## ADA SELF-EVALUATION AND TRANSITION PLAN

### 7: BUILDING ENTRANCES AND EXITS

ITEM	EXISTING BARRIER	BARRIER REMOVAL METHOD	CORRECTIVE TIMELINE
	PATTON	LANDING	
7: Building Entra	nces and Exits		
7.A: Entrance Sign	The accessible entrance is not identified by an ISA.	Provide an ISA to designate the accessible entrances.	Short-term
7.B: Doors	At least one accessible door is not provided at each accessible entrance.	Address barrier issue 7.C to provide at least one accessible door at each accessible entrance.	Long-term
7.C: Door Operating Effort	Fifteen pounds of force is required to operate the door (exceeds the maximum 5 lbs (fire doors may have up to 15 lbs to achieve positive latching).	Adjust door closure or replace door to require no more than 5 lbs of force to operate the door.	Short-term
7.D: Rugs	Rugs are not firmly attached at building entrances.	Firmly attach rugs at entrances.	Short-term

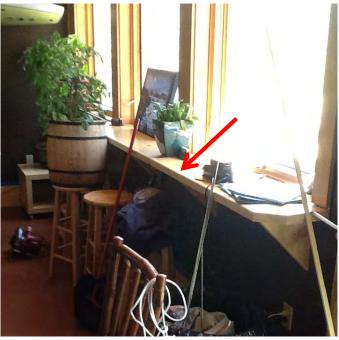
Table height of 31" meets requirements but the clear space between legs is only 29", less than the required minimum 30".

8.H: Knee Space	No wheelchair accessible seating spaces exist.	Provide accessible seating space at counter areas.	Short-term
8.I: Protruding Objects	Small dining tables and the condiment counter exist that protrude more than 4" from the wall.	Provide tables with 30" wide clear spaces.  Provide an end panel for can detection down to a minimum of 27" above the floor on both ends. The panel may extend lower; however, it may not be higher than 27".	Short-term
